# **ADDENDUM NO. 1**

# Town of Wilmington, Vermont

# Hoot, Toot & Whistle Trail Improvement Project

This Addendum Issued: Tuesday July 16, 2024

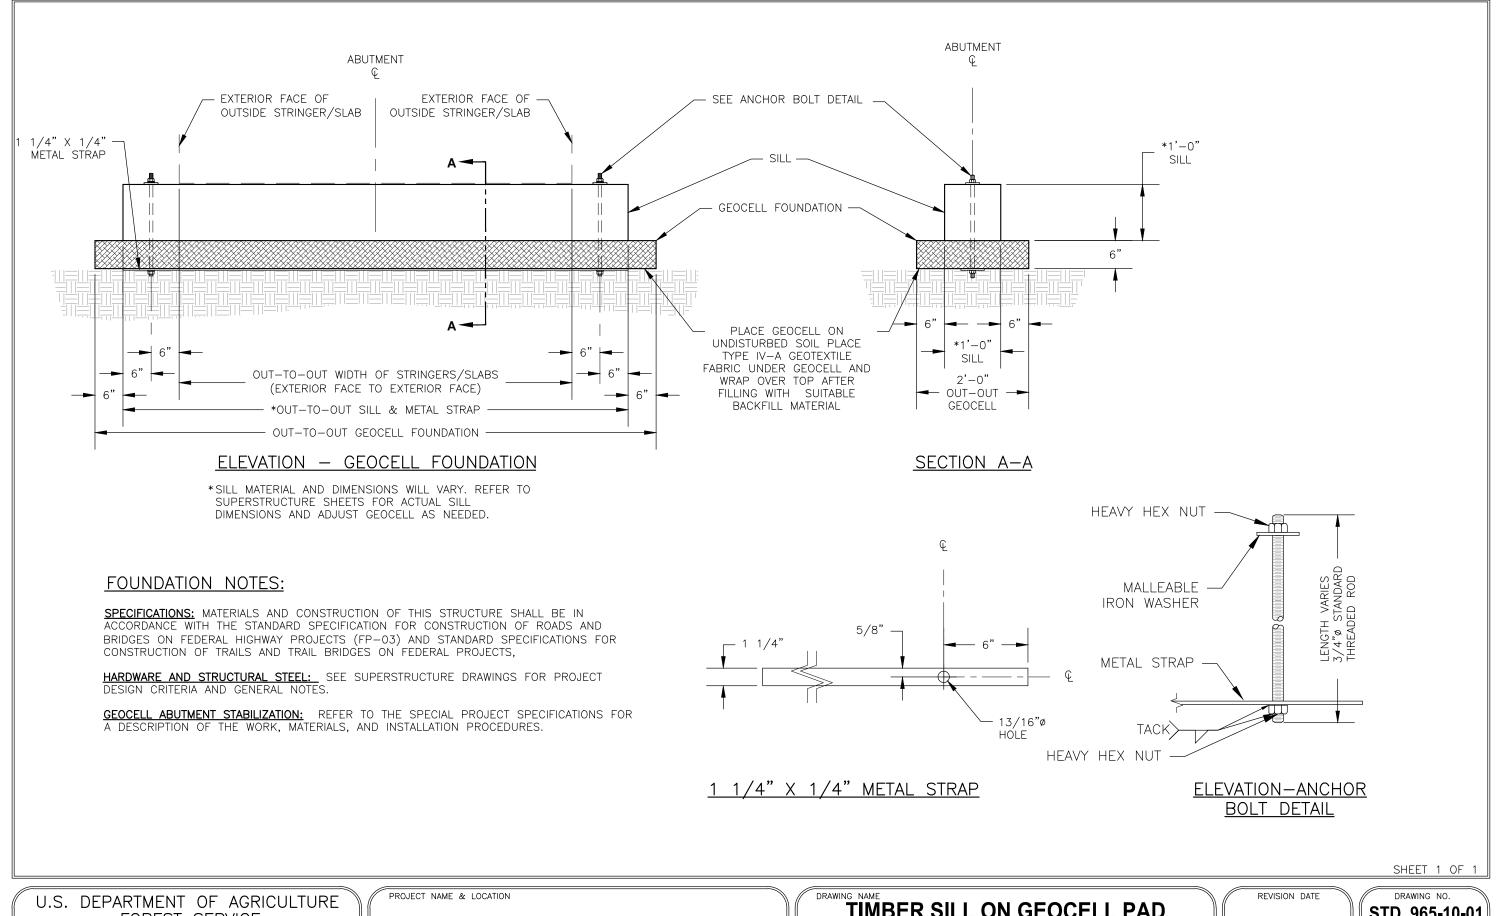
The Base Bid shall include a 35' Length Timber Bridge located at STA 40+10 (Segment 1) eliminating Culvert Drainage Area in this location. See sketch markup below from C102. Refer to updated Bid Form

STD\_965-10-01 SHEET OF

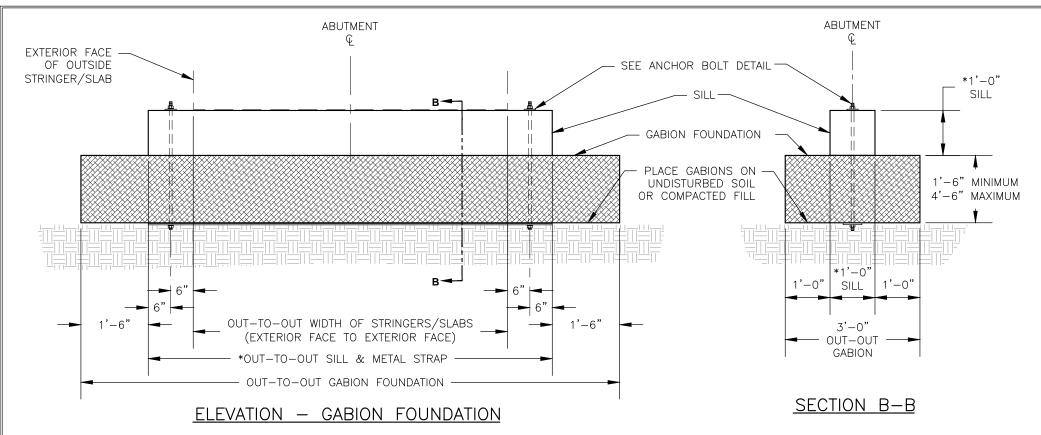
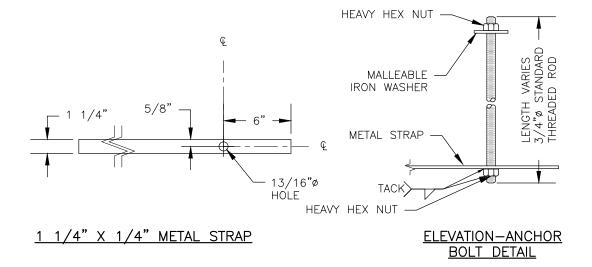
#### **Question 11: What abutments should be used for bridges?**

Answer 11: Refer to attached standard detail sheets (STD\_965-10-01 and STD\_965-20-01) for additional information regarding bridge abutments options, and Trail Specifications.
